BRUNSWICK STEAM ELECTRIC PLANT, UNIT NOS. 1 AND 2
DOCKET NOS. 50-325 AND 50-324/LICENSE NOS. DPR-71 AND DPR-62
REVISIONS TO PLANT EMERGENCY PROCEDURES

Procedure	Revision	Effective Date	Title
OPEP-02.1.1	8	12/17/02	Emergency Control – Notification of Unusual Event, Alert, Site Area Emergency, And General Emergency
OPEP-04.7	4	12/17/02	Brunswick Emergency Notification (Automated Telephone) System

Summary of Revisions

ATTACHMENT 1
Page 1 of 1
Site Emergency Coordinator Actions Flow Chart

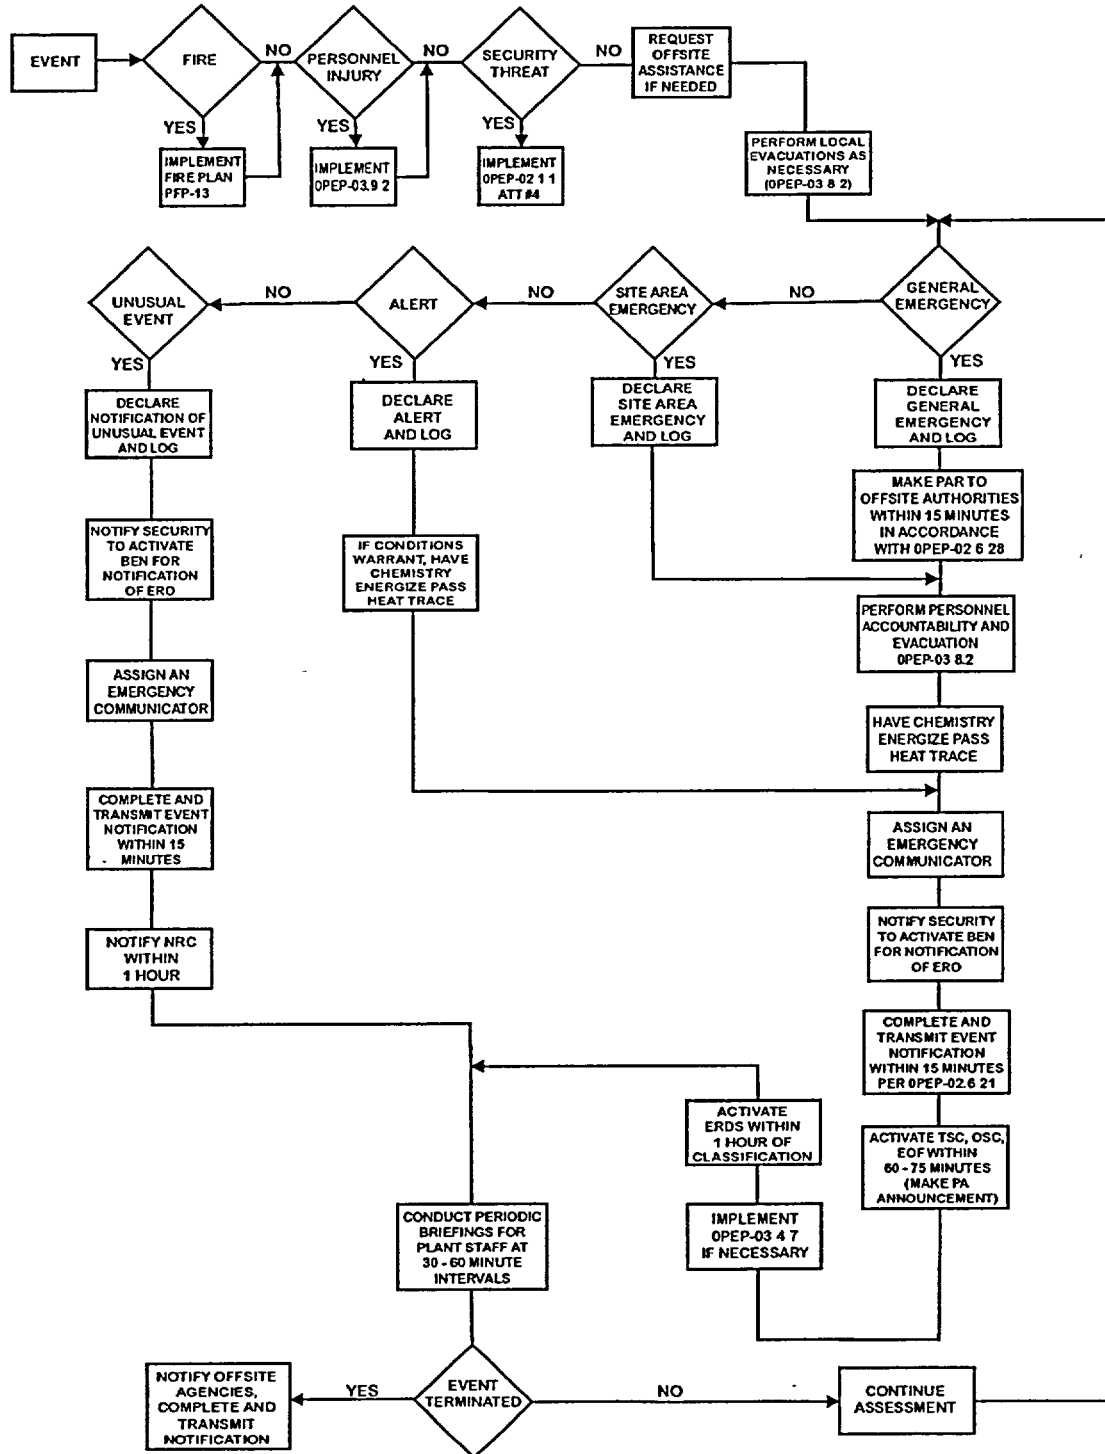
2. Reformatted public address announcement into separate paragraph in Section 6.2.2 for user-friendliness and as a human performance enhancement.
 3. Added security threat information in Attachment 1, Site Emergency Coordinator Actions Flow Chart.

ATTACHMENT 1
Page 1 of 1
BEN System Activation

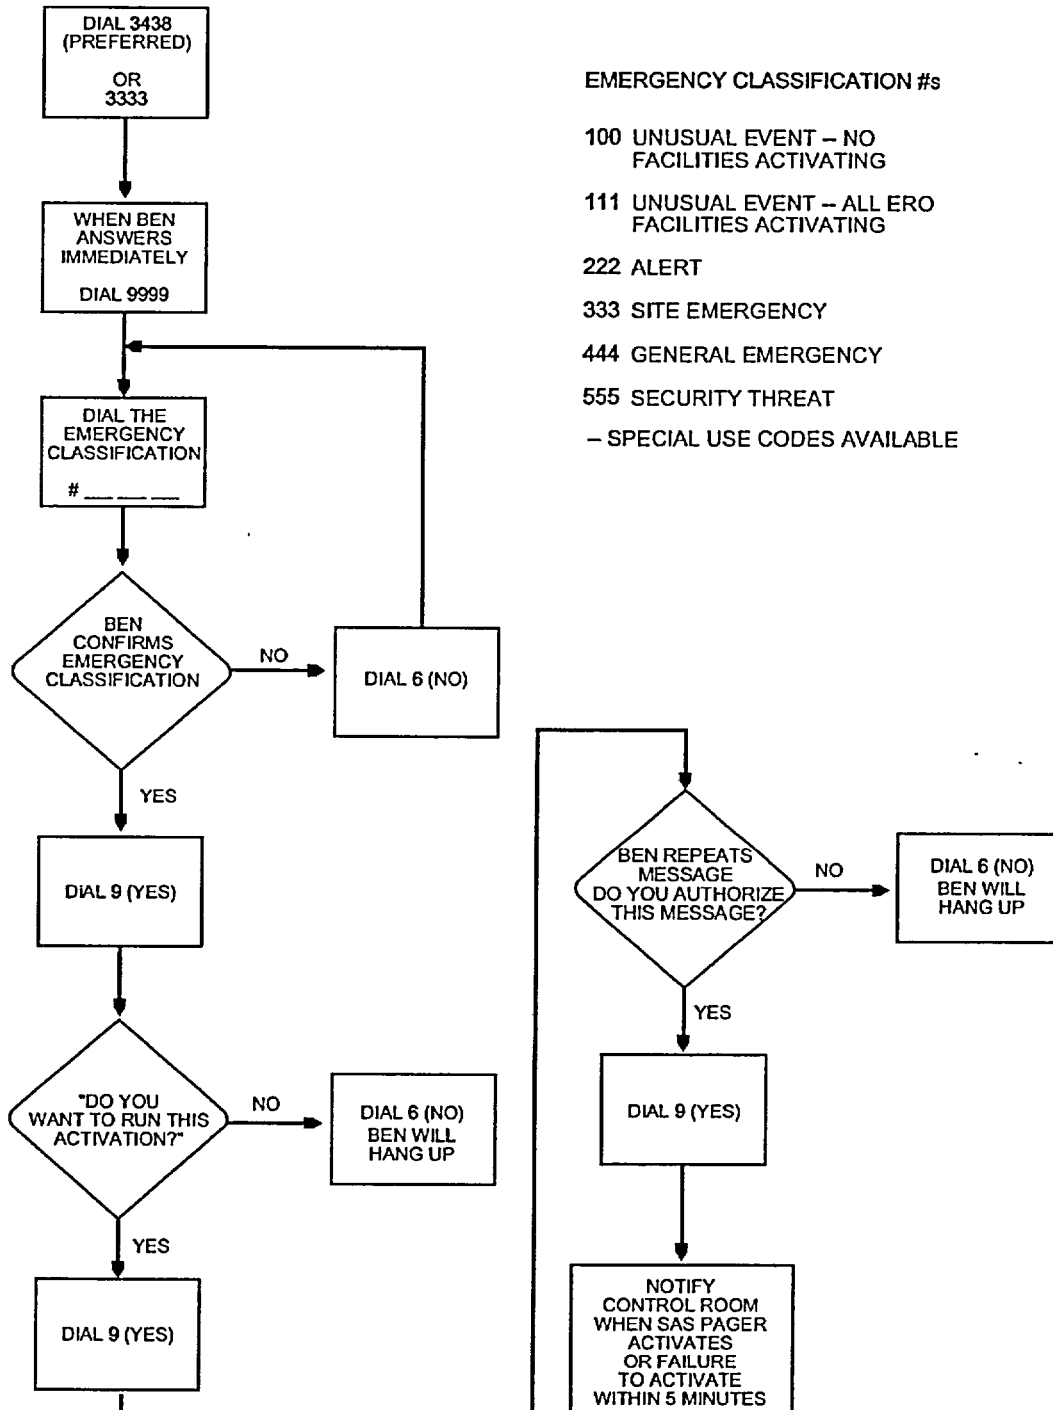
2. Changed Unusual Event scenario code from "000" to "100" in Section 8.1.1 and Attachment 1, BEN System Activation, to reflect software changes to the BEN System.

3. Added scenario code for Security Threat in Section 8.1.1 and Attachment 1.
 4. Changed "five" to "fifteen (15)" minutes in Section 8.2 Note and deleted "12" from Section 8.3 to reflect software changes to BEN System.

5. Corrected typographical error in Attachment 1.
